To:HWDSBAttn:Jesse PereiraJob Name:Waterdown SS
Dust Collector Replacement

Quotation: 25-202R

Submittal Drawings - Electrical

Customer Name:	Hamilton Wentworth District School Board Hamilton, Ontario			
Customer P.O Number:	PO10025559			
Project:	Waterdown District High School			
	Sawdust Collection System			
Engineer:	Giallonardo Engineering Inc. Woodbridge, Ontario

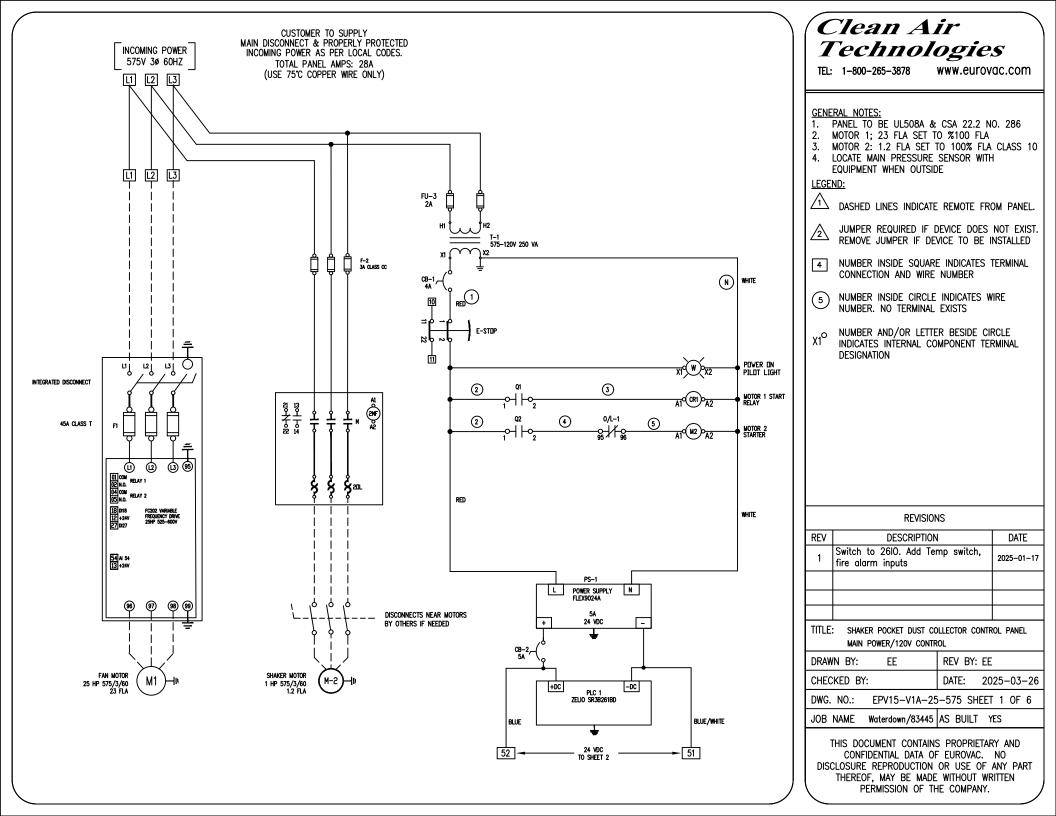
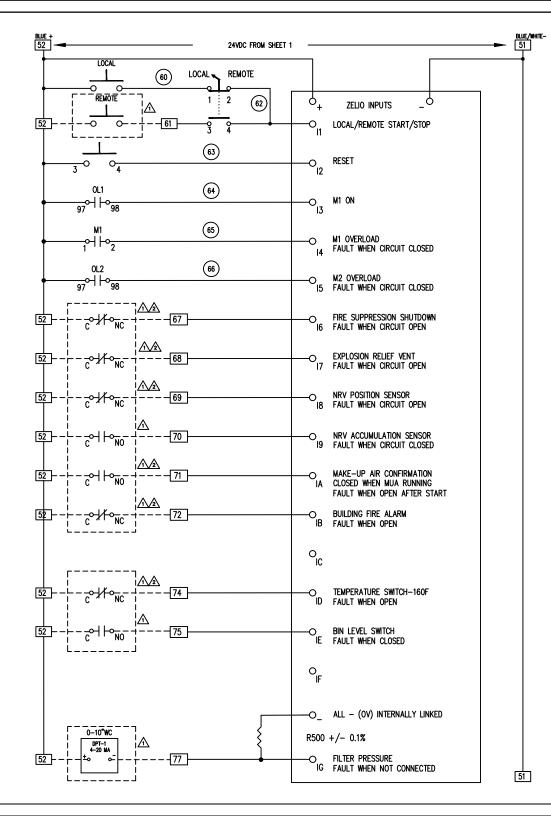
(GEI) SEE ENCLOSED COMMENTS.

(GEI) ELECTRICAL REQUIREMENTS TO BE REVIEWED BY ELECTRICAL ENGINEER.
